Subject: Virgil C. Summer Nuclear Station (VCSNS) Units 2 and 3 Combined License Application (COLA) - Docket Numbers 52-027 and 52-028 Supplement 2 Response to NRC Request for Additional Information (RAI) Letter No. 032

SRP Section: 2.5.4 – Stability of Subsurface Materials and Foundations

NRC RAI Number: 02.05.04-13

Figure 02.05.04-13.8: Boring B-311 - RQD and V_s versus Elevation

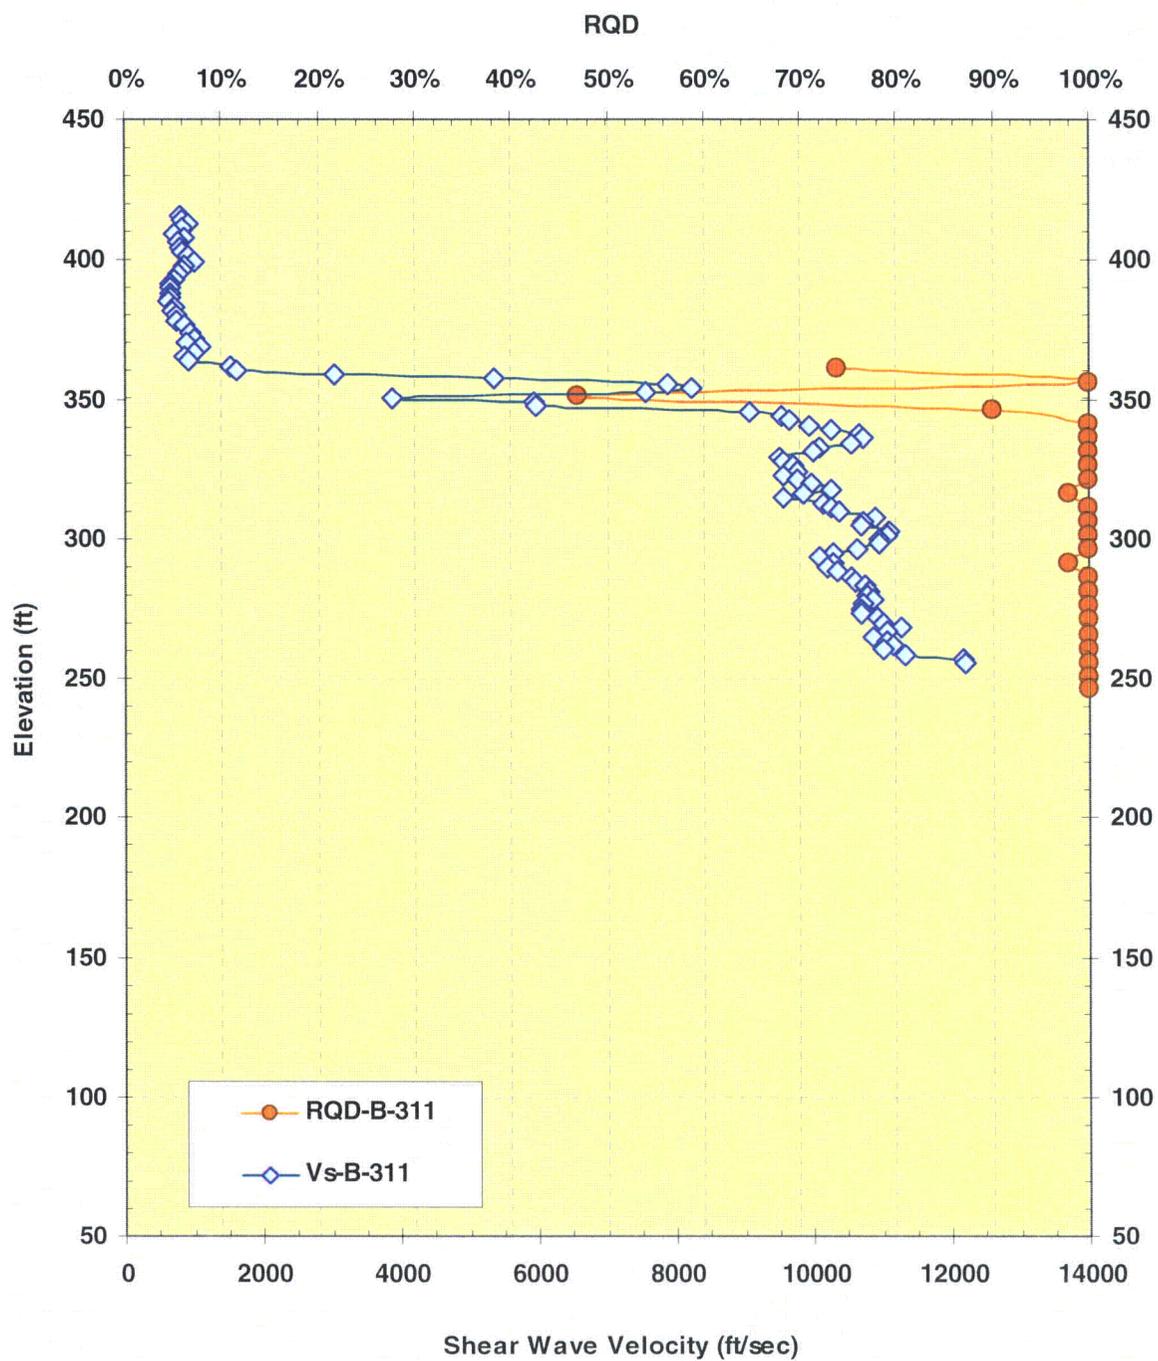
FSAR Section 2.5.4.2.2.1 indicates that the top of Layer V (sound rock) was based on estimates of RQD from the available boring samples as well as measured shear wave velocities determined from the suspension logger. Table 2.5.4-201 indicates that the top of Layer V can vary from as low as elevation 335' to as high as elevation 360'. Figure 2.5.4-211 indicates that measured RQD for sound rock varies from as low as 20% up to 100% with average RQD values exceeding 50%. Please provide information on the correlation of RQD with V_s as well as how average values were determined from the boring data for rock profiles that have such apparent non-uniformity with depth.

Attached are 8 figures that show RQD and V_s values obtained from the 8 boreholes in which the P-S suspension logger was used (4 in Unit 2 and 4 in Unit 3). Note that all of the measured RQD and V_s values are included in these figures, not just those of sound rock.

As noted in FSAR Section 2.5.4.2.2.1, sound rock was generally assumed when RQD exceeded 50%, but RQD values in sound rock were, in fact, typically over 70%. FSAR Table 2.5.4-209, Summary of Engineering Properties, shows RQD for Unit 2 to be in the 80% to 100% range, and RQD for Unit 3 to be in the 90% to 100% range. These Table 2.5.4-209 values are well illustrated in the figures, with only a few RQD values falling below 80% in the Unit 2 borings and even less falling below 90% in the Unit 3 borings. Very few rock cores were obtained in the MWR (RQD values less than 50%).

As would be expected, there is general correlation between RQD and V_s . In the Unit 2 borings, when RQD drops below about 80%, there is a noticeable reduction in V_s (except in B-207 around El. 330 ft, where no reduction in V_s was recorded). Similarly in the Unit 3 borings, when RQD drops below about 90%, there is a noticeable reduction in V_s .

Since there is no dip or bedding in the sound rock, the average values are based on 5 ft intervals of elevation. Note that in FSAR Figure 2.5.4-211(a), which includes values from 15 borings in Unit 2, there are a few RQD values less than 50%. In these cases, there was nothing in the core description to indicate partial or moderate weathering (PWR or MWR) and so the cores were counted as sound rock.

RAI Figure 02.05.04-29.1: Peak ground acceleration (from FSAR 2.5.4-242)

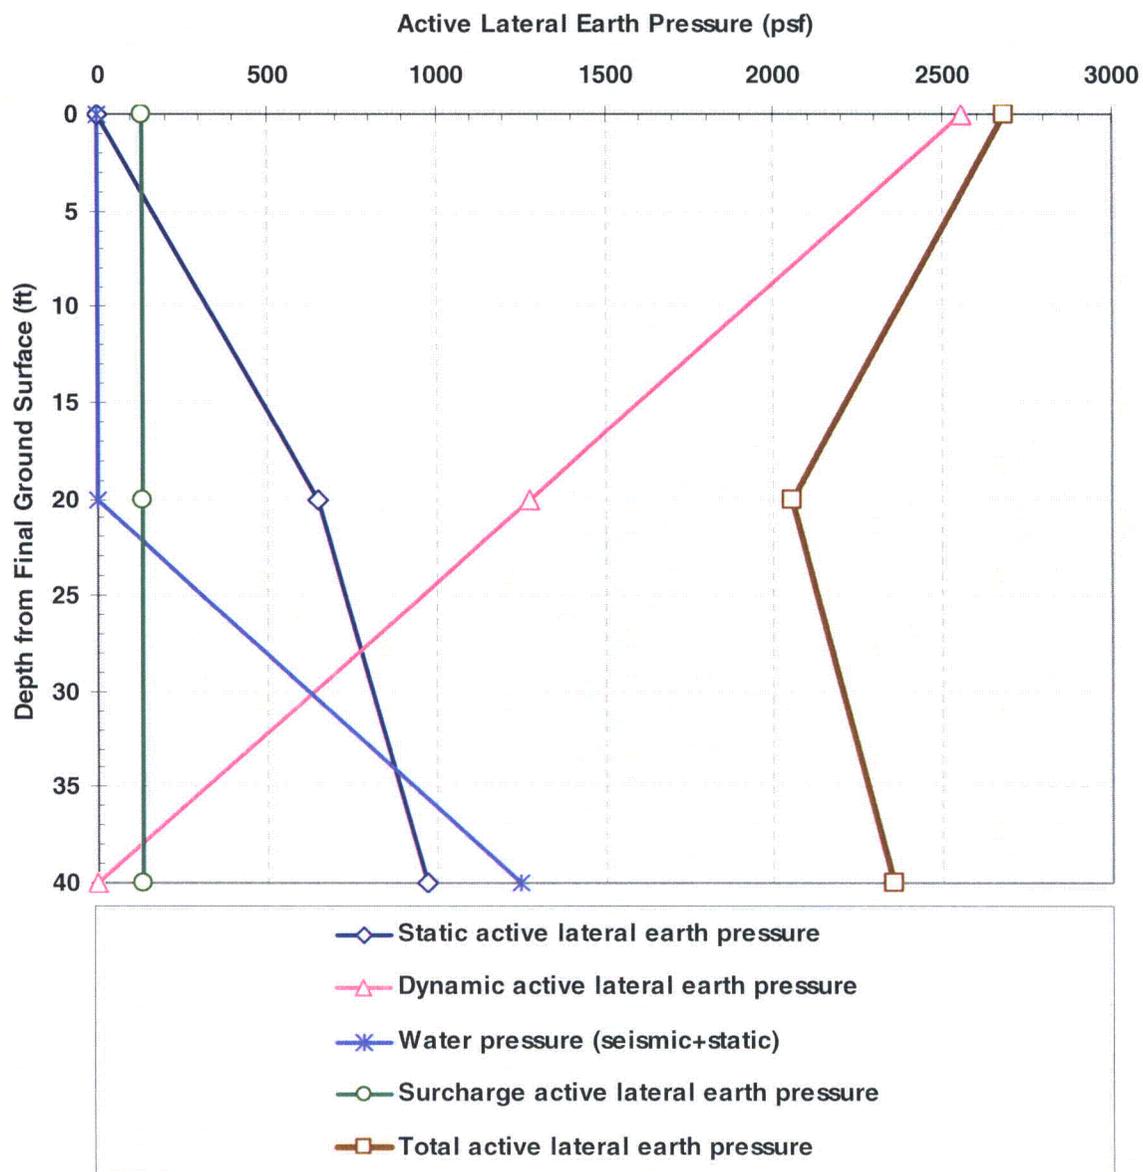
FSAR Section 2.5.4.10.3 indicates that active and at-rest pressures are used for the evaluation of lateral wall pressures. The design of the AP1000 is based on considerations of the development of passive pressures due to horizontal seismic loadings, and how the total lateral load is distributed to both lateral wall loads and base shear. The pressure diagrams shown in FSAR Figures 2.5.4-243 and 244 indicate dynamic pressures distributions, which do not follow the anticipated results typically calculated from the recommendations in ASCE 4-98 and 43-05. Please provide information justifying the calculation of these pressure diagrams and how they compare to the estimates used in the AP1000 design process.

FSAR Figure 02.05.04-243 – active lateral earth pressure – was developed using the Mononobe-Okabe method to calculate dynamic active lateral earth pressures. This figure applies to the prospective yielding retaining walls at the site, rather than the earth-retaining walls of the nuclear island structures. As ASCE 4-98, Section 3.5.3.3 states, the Mononobe-Okabe approach may be used to establish dynamic soil pressures, provided that wall displacements required to develop the active earth pressure can be tolerated without loss of wall function. According to Reference 1, p. 1773, use of the horizontal ground acceleration ($k_h \cdot g$) for design at the level of the base of the wall may result in underestimating the movements; it is preferable to use the acceleration (and the velocity) at the surface of the backfill, or to use an average of the values between the surface and the base of the wall. The maximum peak horizontal ground acceleration of 0.55g (obtained for Unit 2 in-situ soils as shown in RAI Figure 02.05.04-29.1) was conservatively used for developing the seismic active earth pressure diagrams (i.e., $k_h=0.55$), even though the peak horizontal ground acceleration obtained for the structural fill was 0.38g (from RAI Figure 02.05.04-29.6 at 100 Hz).

RAI Figure 02.05.04-30.1 Earth Pressure due to Compaction by Rollers (Reference 2, Figure 14)

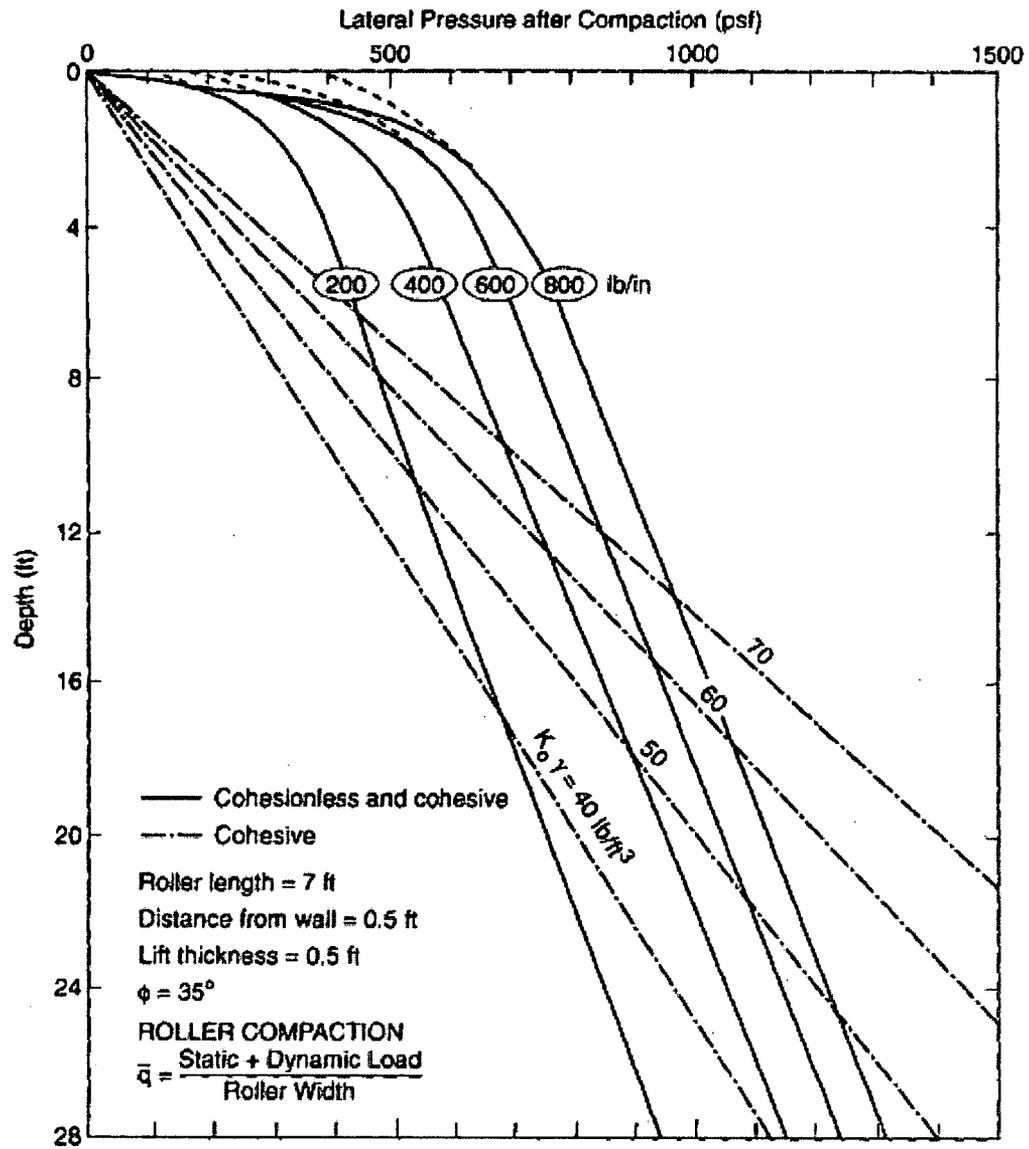
FSAR Section 2.5.4.10.3 indicates that lateral pressure effects due to potential soil compaction are not included in the lateral pressure computation. References such as “Compaction-Induced Earth Pressures Under K_0 -Conditions” by Duncan and Seed indicate that significant lateral pressures may be developed even with use of light compaction equipment. Please provide information on the planned compaction procedures to be used, impact on lateral pressures, reduced compacted density and shear wave velocity which may impact horizontal SSI response.

As part of this evaluation, the methodology described in References 1 and 2 is pursued to compute the compaction-induced pressures under at-rest conditions. The pressure diagram associated with the assumed compactor is derived from RAI Figure 02.05.04-30.1 (from Reference 2, Figure 14). This pressure diagram applies to static or vibratory

rollers (other available design charts are for vibratory plates and rammers). On this figure, curves are developed for line loads (q) of 200, 400, 600, and 800 lb/in. At-rest earth pressure curves are superimposed on the curves for various q values. To be on the conservative side, the highest available line load ($q = 800$ lb/in) is selected, which produces the highest lateral pressure. For conditions other than those on which the charts are based, adjustments are made using the multiplier factors in RAI Table 02.05.04-30.1 (from Reference 2, Table 12).
